UNITED STATES PATENT AND TRADEMARK OFFICE

APPLICATION NO.	FILING DATE	FIRST NAMED INVENTOR	ATTORNEY DOCKET NO.	CONFIRMATION NO.
10/040,386	01/09/2002	Yoshito Sakai	111636	2053

Office Action Summary

DETAILED ACTION

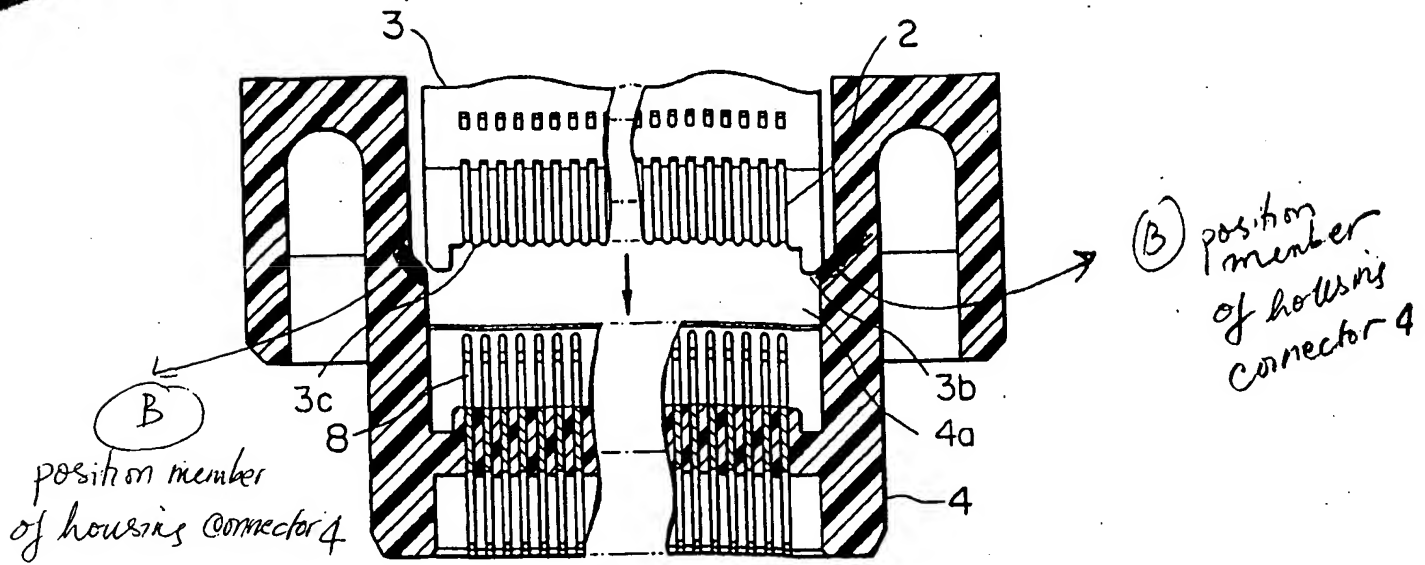
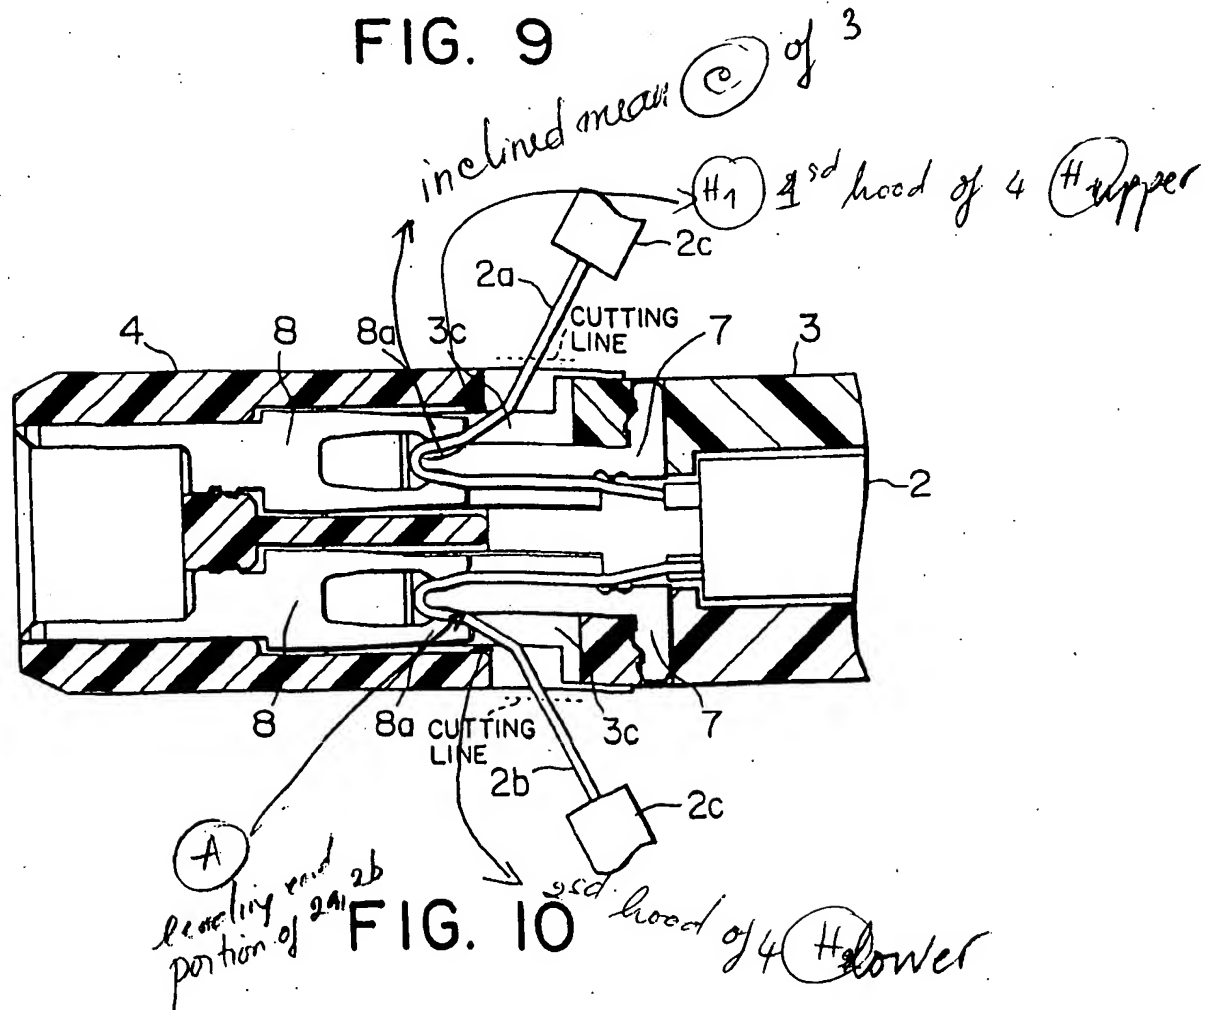
In regard to claim 13, Higuchi et al discloses (Attachment 1) a connector assembly for a flat wire member, comprising a first connector (adjacent 4) including connecting terminals (8) accommodated therein, each terminal (8) having a contact arm (8a), and a second connector (adjacent 3) for holding a flat wire member (2), the second connector (adjacent 3) including a plate-shaped supporting member (3c) for supporting a leading end portion (A) of the flat wire member (2), and a housing (3) for retaining the leading end portion (A) on the supporting member (2), the supporting member (3c) and the housing (3) holding the leading end portion (A) in such a way that the leading end portion (A) is movable in a widthwise direction (widthwise direction from 3c to 3b of figure 9), with a portion (A) of the leading end portion (A) being exposed on the housing (3), the first (adjacent 4) and second connectors (adjacent 3)

having structures (as described above) to couple the connectors with each other by slidably fitting portions (4, 8, 8a, 3, 2, 2a, 2b, 7, 3c) of the connectors (adjacent 4 and 3) one on the other, with the leading end portion (A) being inserted into the first connector (adjacent 4) to engage the contact arms (8a), and the first connector (adjacent 4) further including a positioning member (B) which is to engage a side of the leading end portion (A) of the flat wire member (2) to position the leading end portion (A) in its widthwise relative to the contact arm (8a) when the leading end portion (A) is inserted into the first connector (adjacent 4).

In regard to claim 24, Higuchi et al discloses (Attachment 1) the connector assembly wherein the second connector (adjacent 3) further includes means (C) for placing the flat wire member (2) on the plate-shaped supporting member (3c) in a state that the flat wire member is inclined (adjacent C) downward toward its leading end (A of 2a,b) with respect to a plane (engaged surfaces of 4 and 3c) of the plate-shaped supporting member (3c) to prevent interference between the leading end (A) and the first connector (adjacent 4) when the leading end portion (A) of the flat wire member (2) is inserted into the first connector (adjacent 4).
